SUBJECT: Addendum No. 1
City of Lookout Mountain, GA
Chickamauga Trail Pump Station Improvements

ADDENDUM NO. 1

CHICKAMAUGA TRAIL PUMP STATION IMPROVEMENTS

CITY OF LOOKOUT MOUNTAIN, GEORGIA
GEFA LOAN NUMBER: GF2024017
CTI PROJECT NO. G24017-01

E-002.1

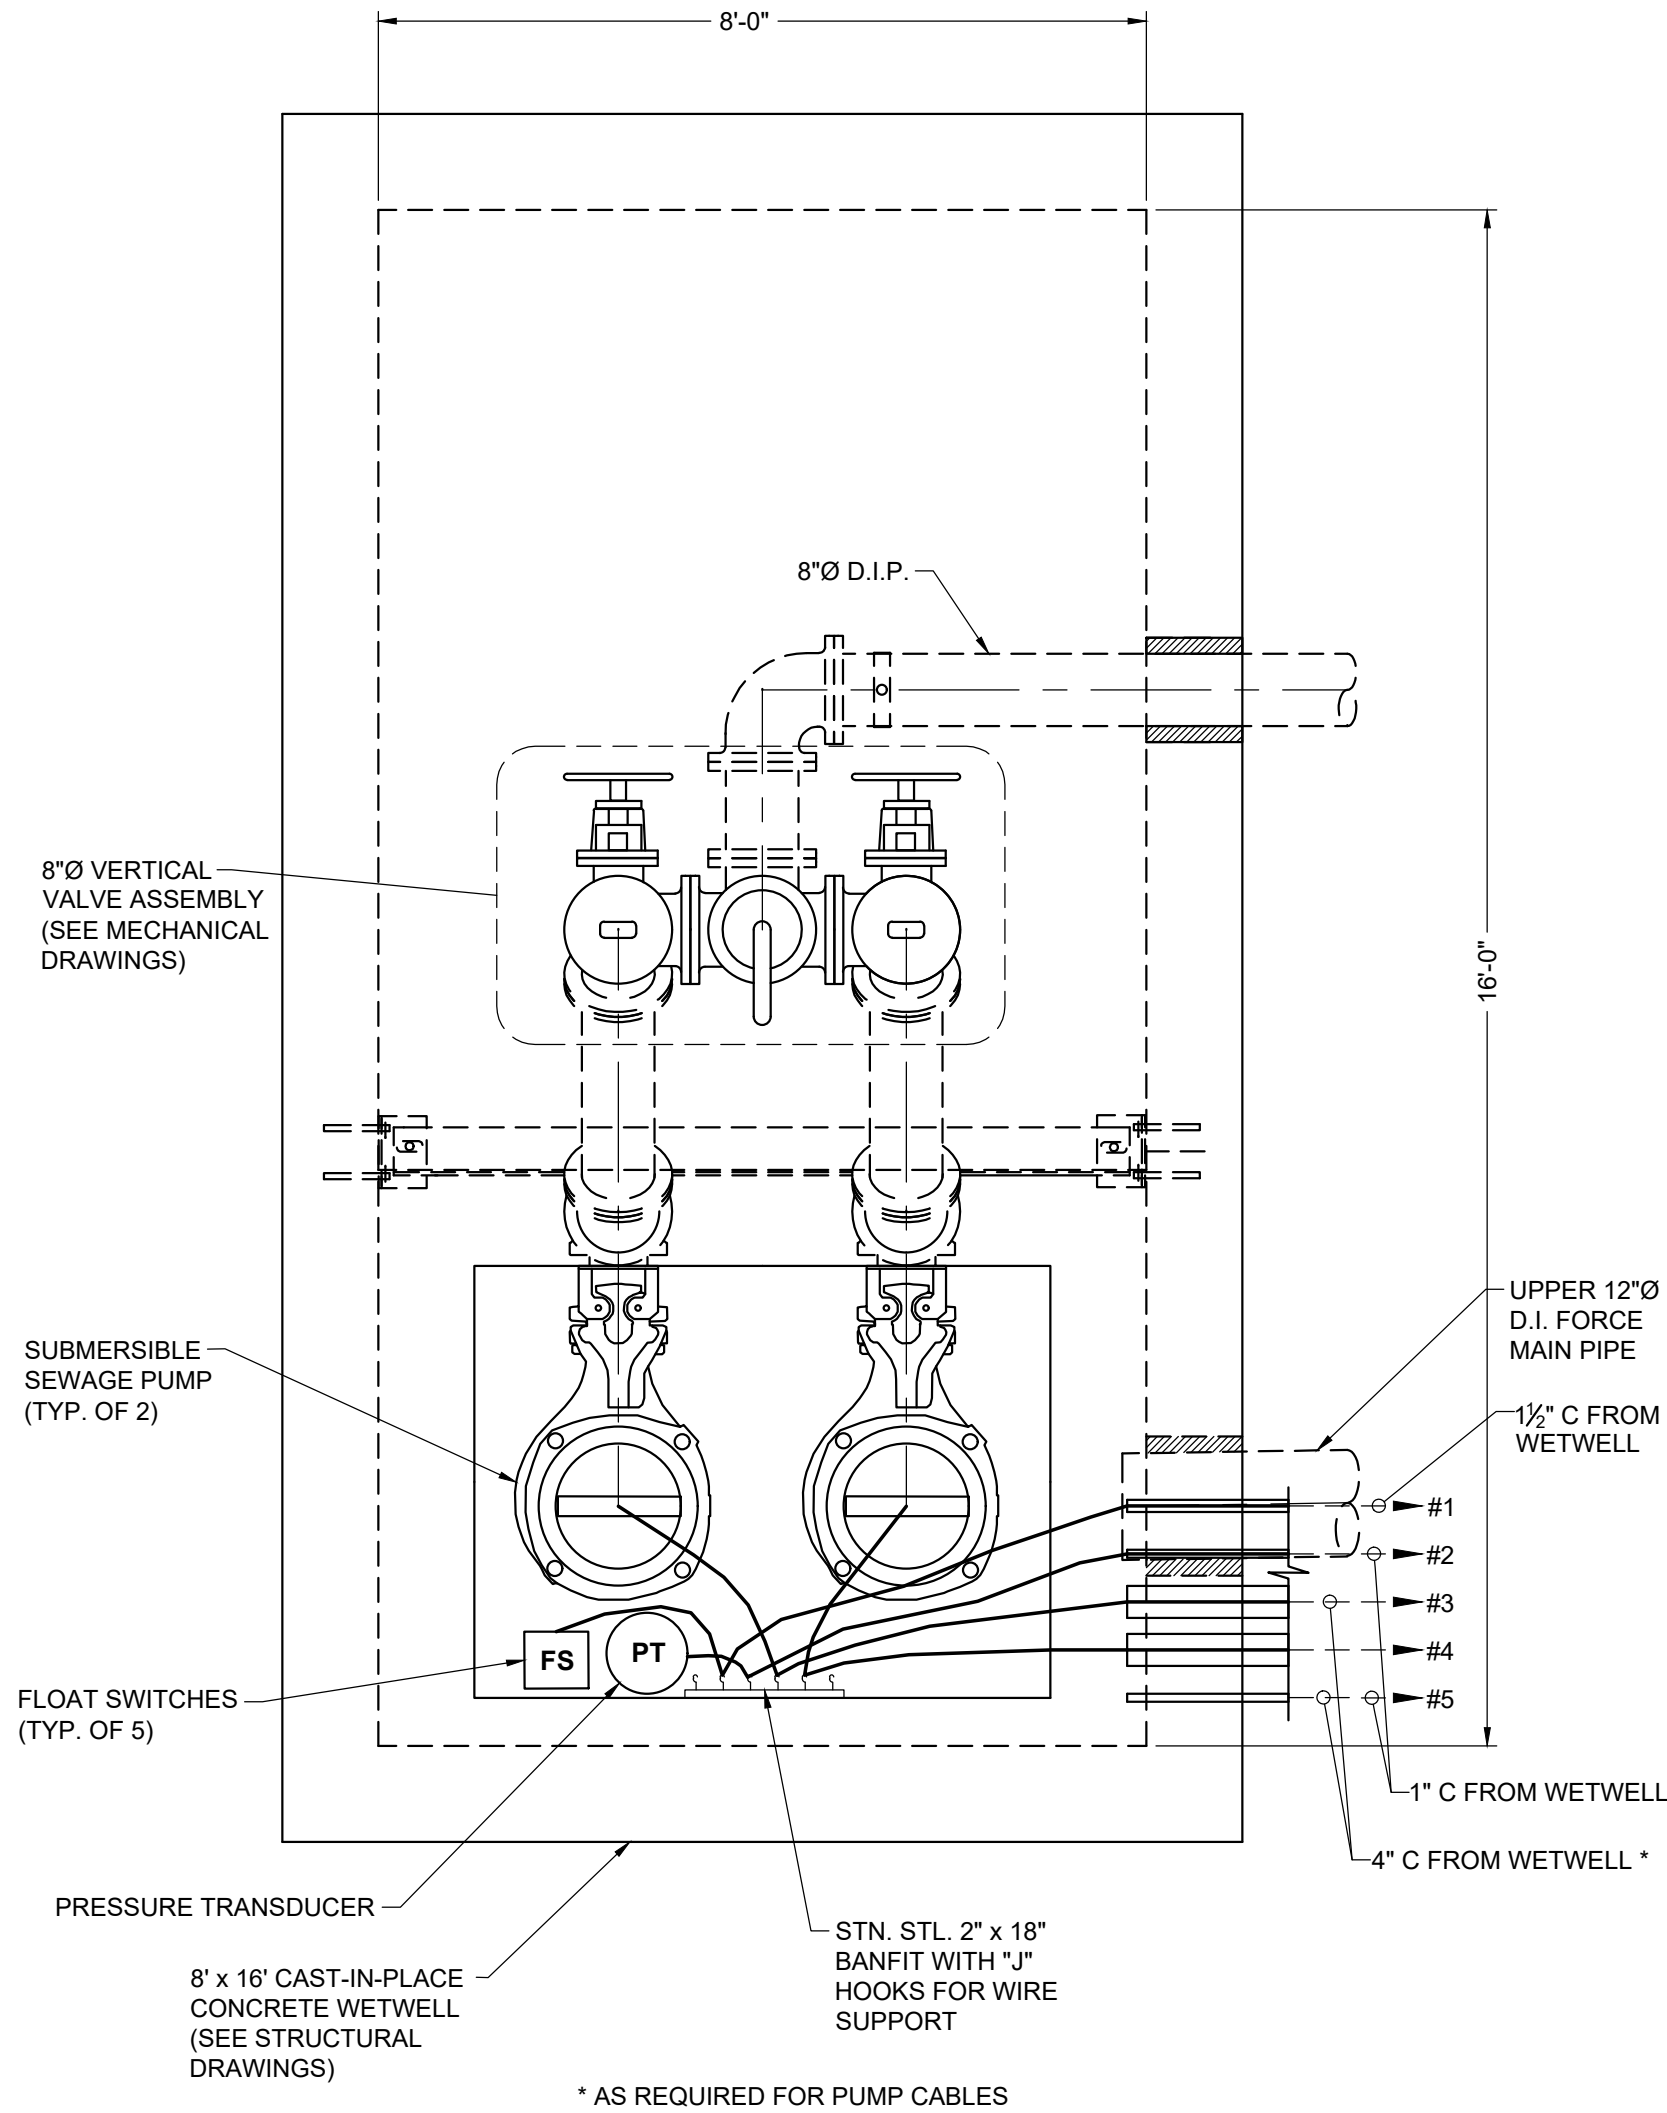
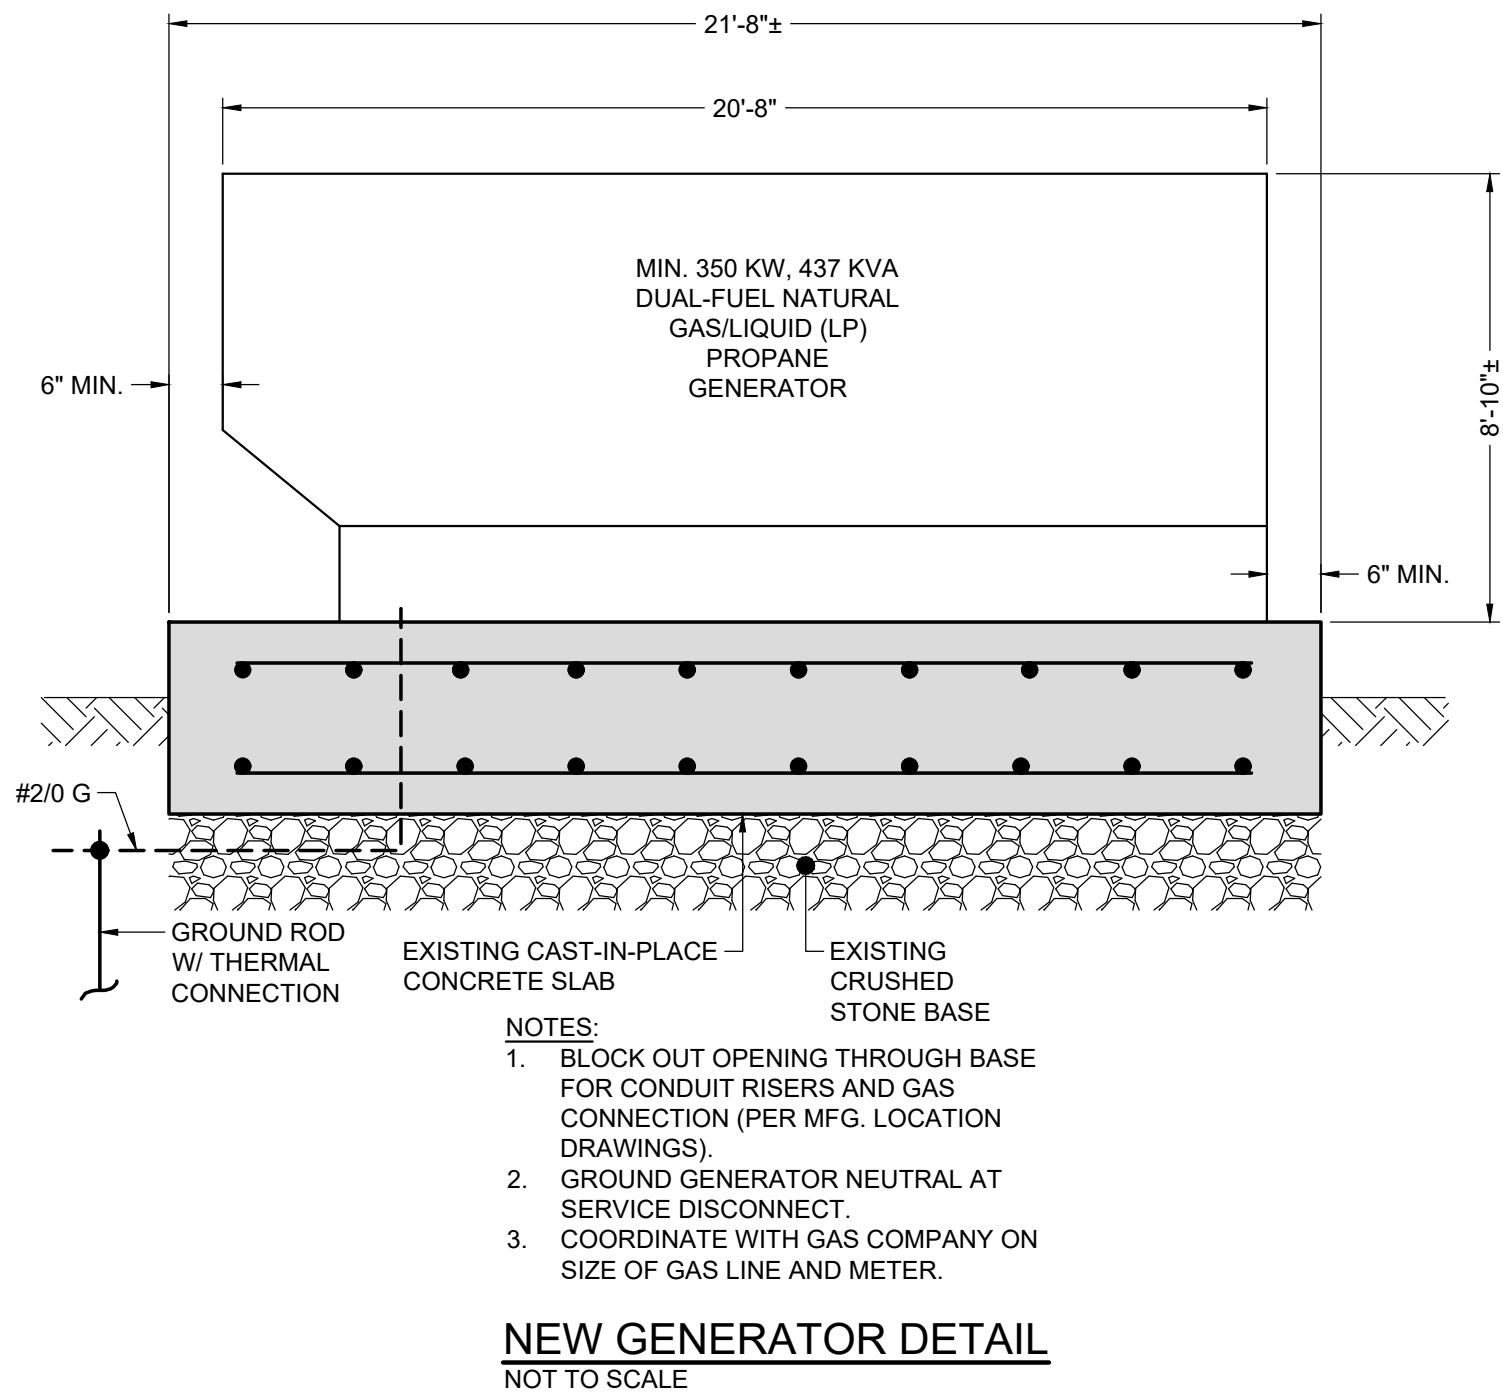
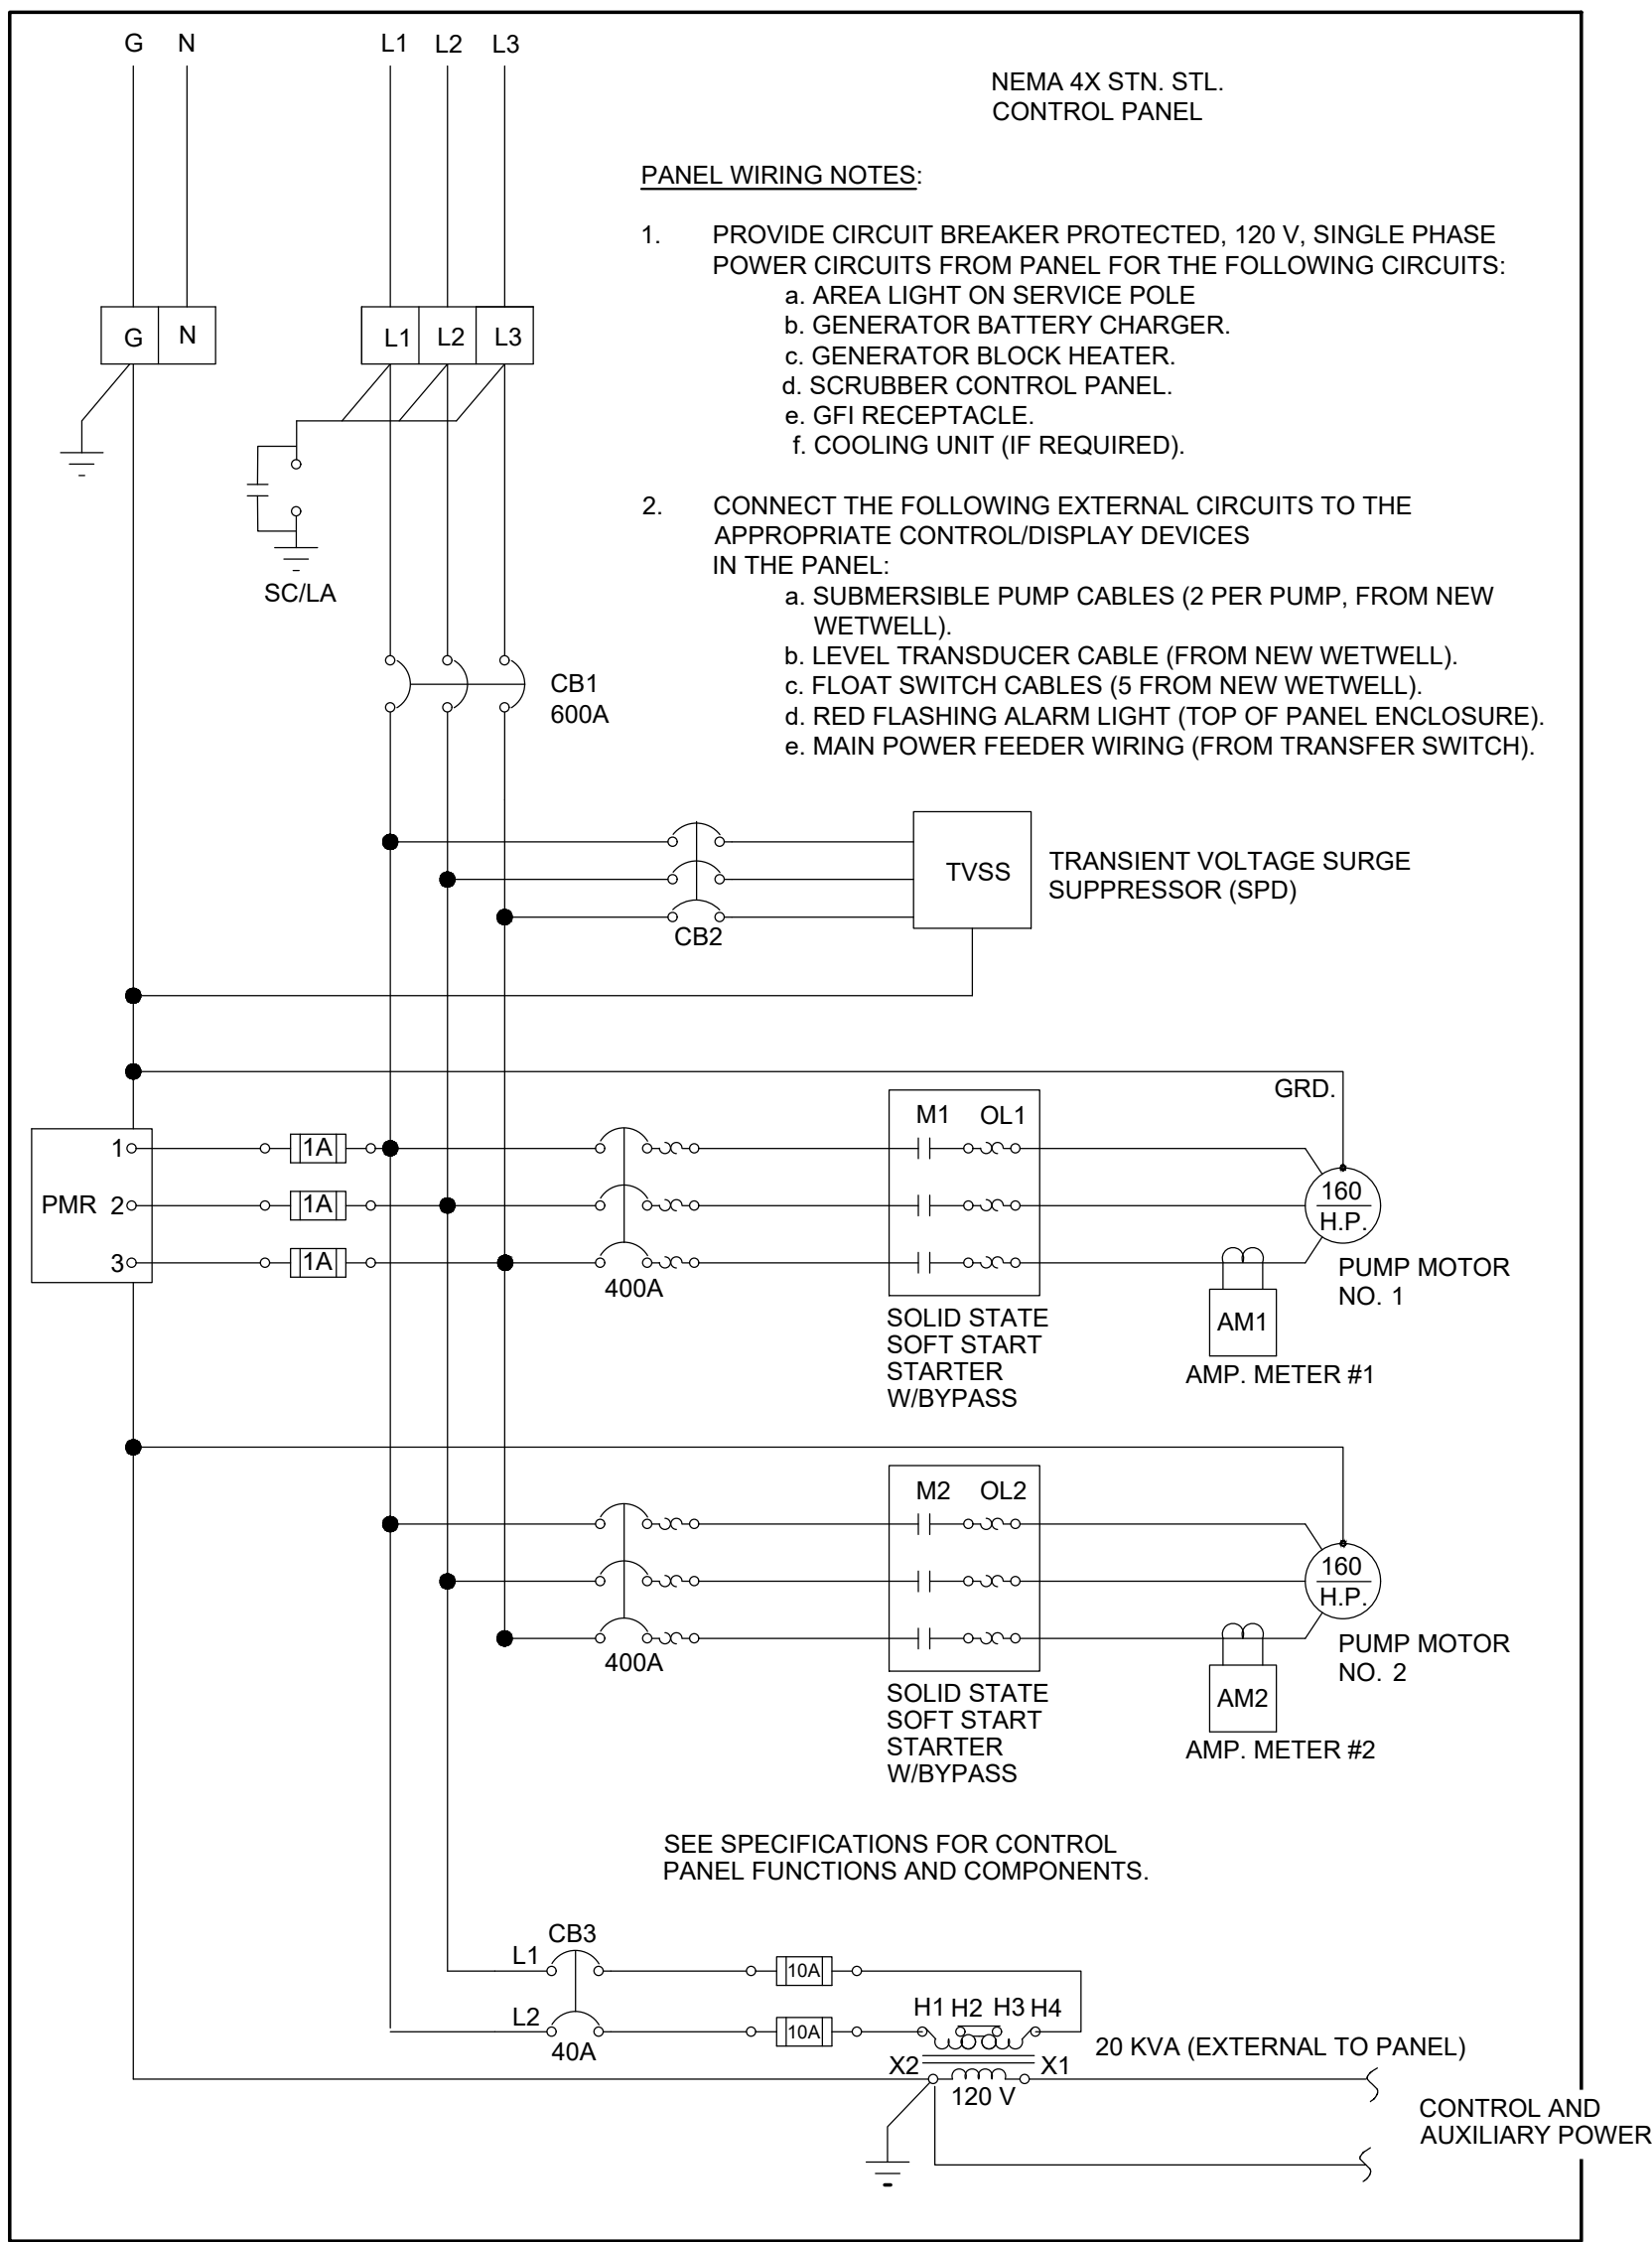
REVISIONS	DATE	BY	APPD	DESCRIPTIONS
1	08/25	GMC	GMC	LENGTHENED MASONRY BUILDING & REVISED BLDG ELECT HVAC LEGEND
